**SYDNEY METRO MARTIN PLACE
STATION INTEGRATED STATION
DEVELOPMENT – NORTH SITE**

**ACCESSIBILITY REPORT
STAGE 2 SSD DA**

**DOCUMENT REFERENCE NUMBER
CSWSMP-MAC-SMA-AC-REP-000120**

Morris Goding Accessibility Consulting

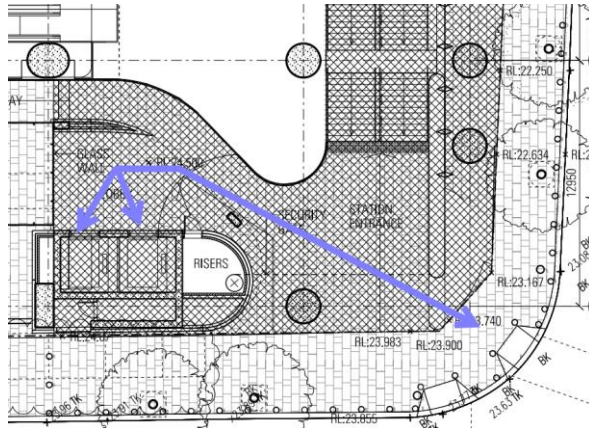
The new accessible path of travel will be as follows. First, there will be an accessible path of travel from the public footpath on Elizabeth Street to the lift lobby on Ground Level for passenger lifts LN1 and LN2. This is

illustrated in the following (not-to-scale) extract from drawing CSWSMP-MAC-SMN-AT-DRG-DA-300000:

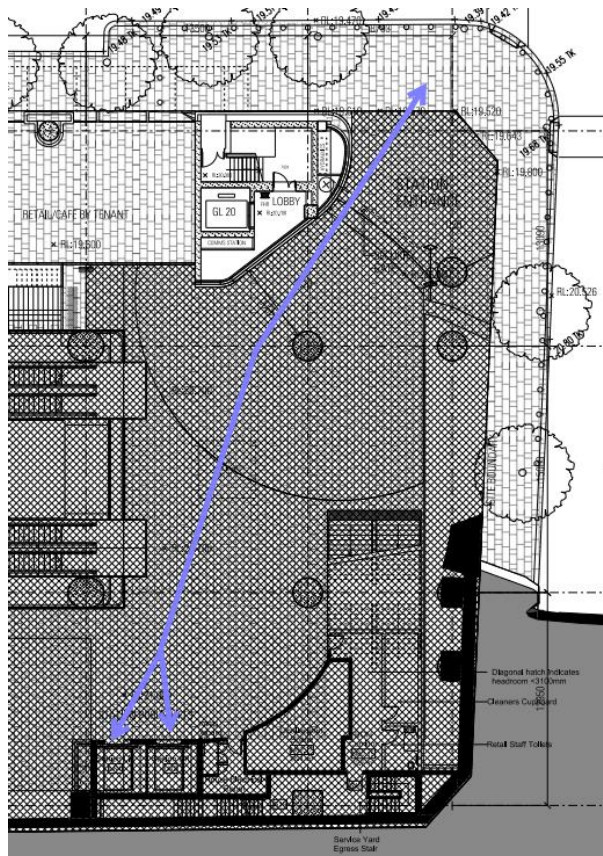
There will, thereafter, be an accessible path of travel from the passenger lift through the North Tower on Lower Ground Level to the public footpath on Castlereagh Street. This is illustrated in the following (not-to-scale) extract from drawing CSWSMP-MAC-SMN-AT-DRG-DA-308000:

The above arrangement will represent a substantial improvement on the existing degree of accessibility for pedestrians with a disability along Hunter Street.
